FINAL
ENVIRONMENTAL IMPACT REPORT

METROPOLITAN
TRANSPORTATION AUTHORITY
WEST LOS ANGELES
TRANSPORTATION FACILITY
AND
SUNSET AVENUE PROJECT
VENICE

(ENV 2004-1407-EIR)
(SCH No. 2003121036)
(SCH No. 2004031139)

FEBRUARY 2005

Revised Figure IV.A-8
Sunset Avenue Project
Project Sections

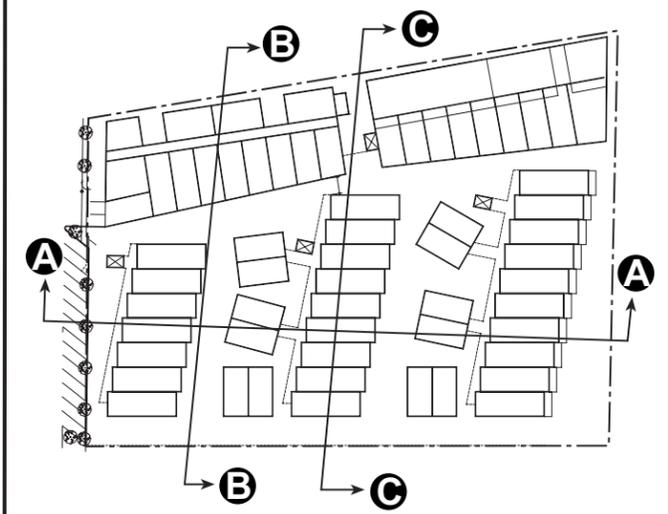
The Draft EIR includes a site plan of the Sunset Avenue Project on Figure II-4 on page 73 of Volume I of the Draft EIR, and cross-sections of the project buildings on Figure IV.A-8 on page 115. The heights and their relationship to the surrounding roadways are also discussed on pages 113 through 117 in Volume I, Section IV.A, Aesthetics, of the Draft EIR. Figure IV.A-8 has been enhanced to include dimensions and a scale. Please refer to the revised Figure IV.A-8 in Section II, Corrections and Additions, of this Final EIR. As indicated, the tallest five story buildings, with heights of approximately 56 feet would be substantially setback from the surrounding roadways.

PEDESTRIAN ROUTES TO WESTMINSTER AVENUE SCHOOL

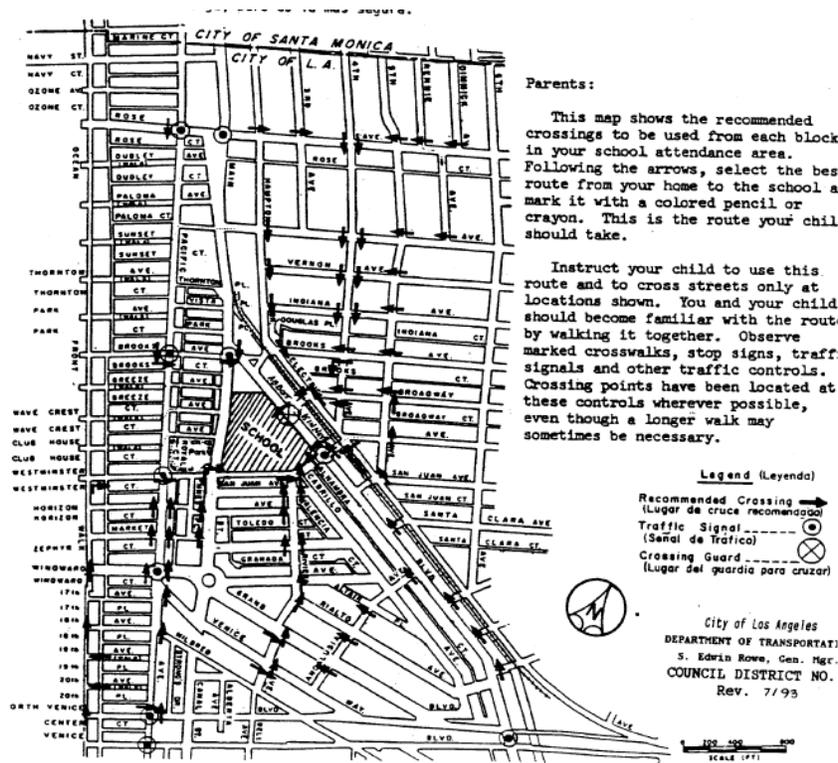
COMMENT 18-3

RESPONSE 18-3

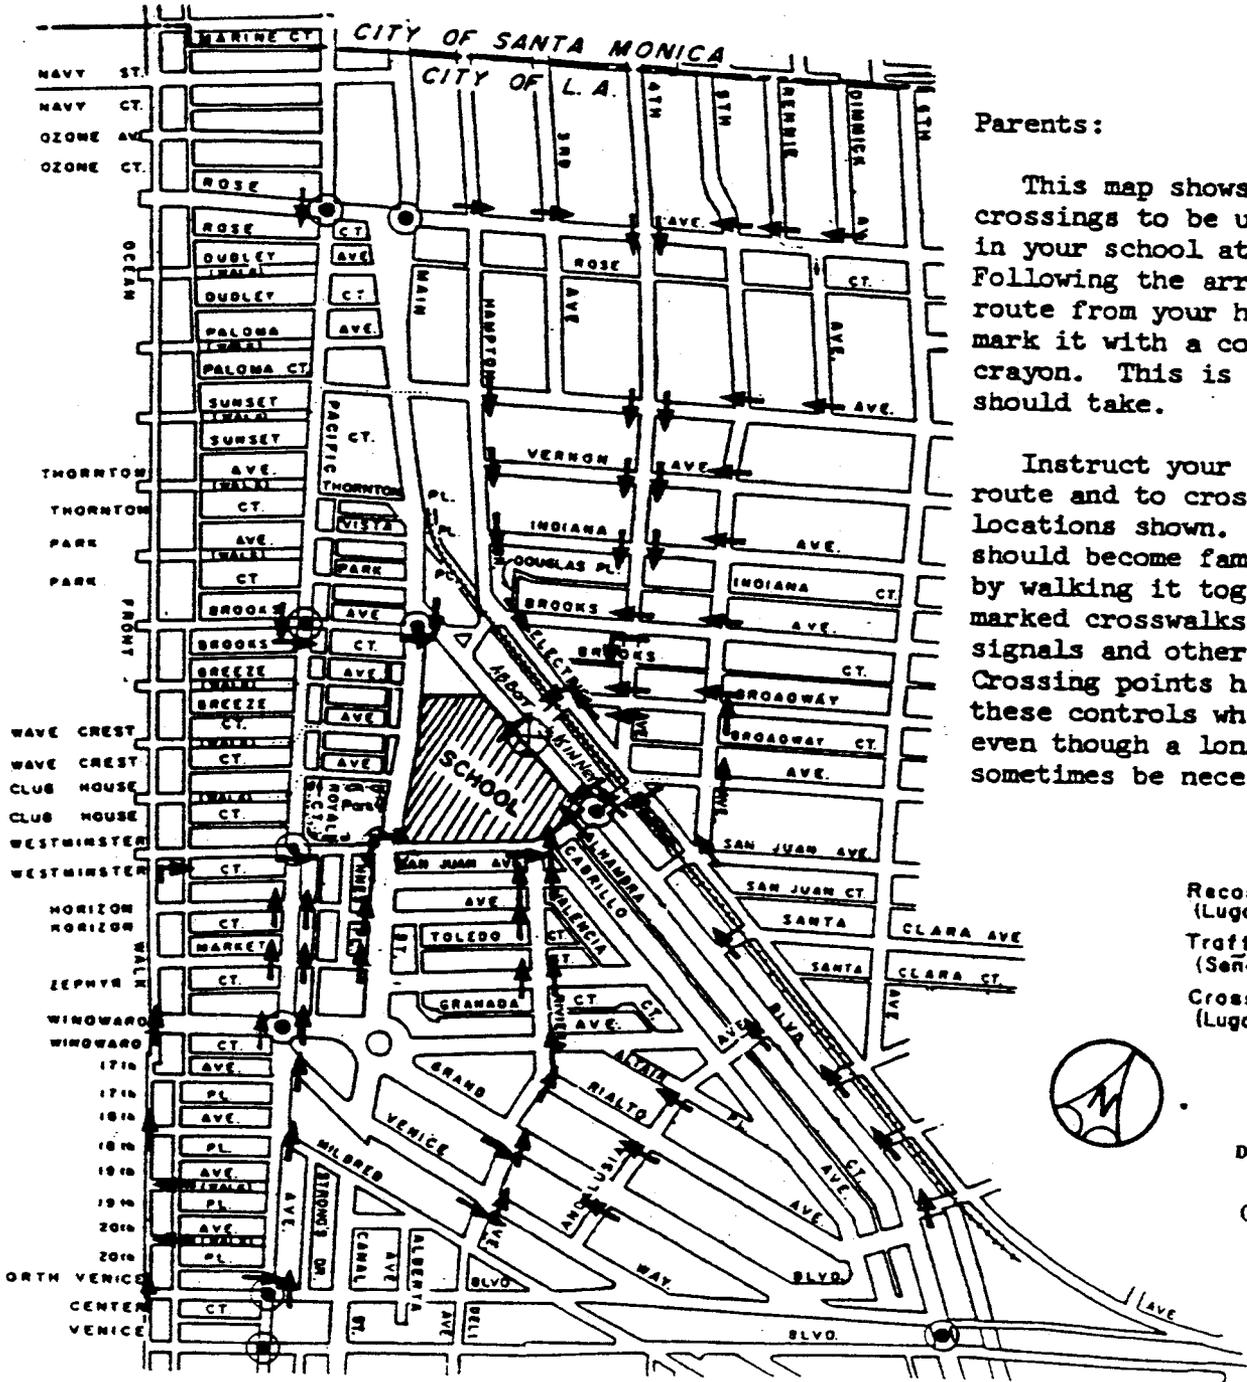
- Contractors must guarantee that a safe and convenient pedestrian route along the School's Pacific Avenue Walk Route to Westminster Elementary School is maintained. The "Pedestrian Routes to Westminster Elementary School" map will be provided upon request.

- Contractors must maintain ongoing communication with the administrator of Westminster Elementary School, providing sufficient notice to forewarn children and parents when existing pedestrian and vehicular routes to school will be impacted.
